**MINUTES**  
**Del Monte Land Use Advisory Committee**  
**Thursday, October 15, 2020**

1. **Project Name:** ALLEN JOHN O  
**File Number:** PLN200051  
**Project Location:** 1155 SOMBRIA LN PEBBLE BEACH  
**Assessor's Parcel Number(s):** 008-281-023-000  
**Project Planner:** JOE SIDOR  
**Area Plan:** DEL MONTE FOREST LAND USE PLAN  
**Project Description:** Combined Development Permit consisting of: 1) Coastal Administrative Permit and Design Approval to allow the partial demolition and remodel of the existing single family dwelling, including the conversion of an existing 559 square foot garage into habitable space and the addition of 988 square feet; and the construction of a 1,535 square foot detached garage, a 304 square foot office and a 3,583 square foot storage basement; and 2) Coastal Development Permit to allow development within 750 feet of known archaeological resources.

**Re: Combined Development Permit Application PLN200051  
1155 Sombria Lane, Pebble Beach**

1155 Sombria Lane

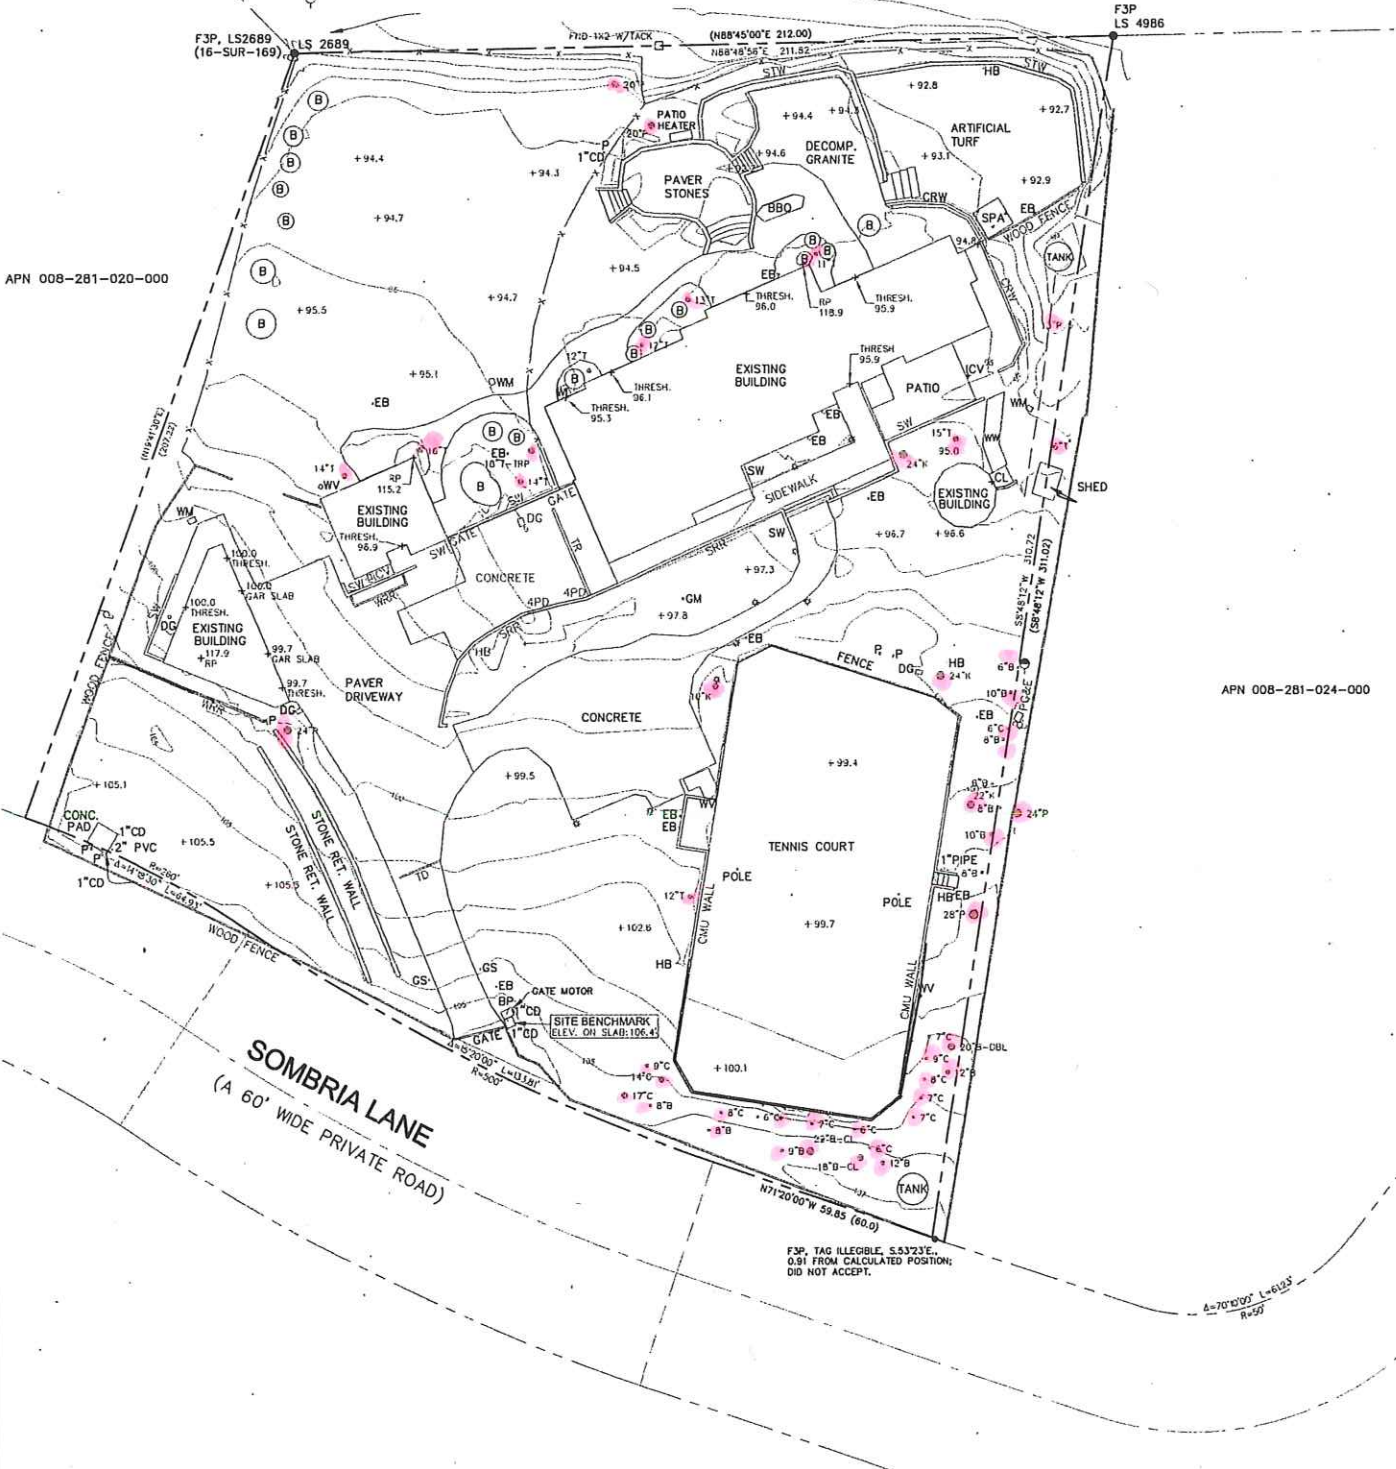
**May 2012 satellite image:** This image shows an abundant tree canopy on the property, largely consisting of Monterey Cypress and Monterey Pine. The foliage of these two species is similar in color, while the foliage of the Monterey Pine is more rounded on the ends, as opposed to the more pointed branch tips of Monterey Cypress. In the lower portion of the image, just to the right of the center, it is possible to see the shadows of the narrow branch tips of the Monterey Cypress. Close to the center of the image is the shadow of a tall, single-trunked Monterey Pine distinguishable by the more rounded branch tips. Where the tree crowns are intermingled, it was not possible to distinguish the Cypress and the Pines with the equipment available, although from the breadth of the tree crowns and their size in comparison to structures, it appears that most of the trees were mature. The approximate canopy lost between the date of this image and the following April 2015 image is delineated in red near the top of this image.

**April 2015 satellite image:** When compared to the May 2012 image, it is apparent that the portion of the canopy delineated in the previous 2012 image has been lost. The approximate canopy lost between the date of this April 2015 image and the following March 2016 image is delineated in red.

**March 2016 satellite image:** When compared to the April 2015 image, it is apparent that the portion of the canopy delineated in the previous 2015 image has been lost. The approximate canopy lost between March 2016 and October 2016 is delineated in red near the top of this image. NOTE: Delineated in black near the top of this image is additional canopy lost between the same dates, but these trees appear to be outside the fence and on Pebble Beach Company property.

**October 2016 satellite image:** When compared to the March 2016 image, it is apparent that the portion of the canopy delineated in red in the March 2016 image has been lost. See the area where the blue tarp is located.
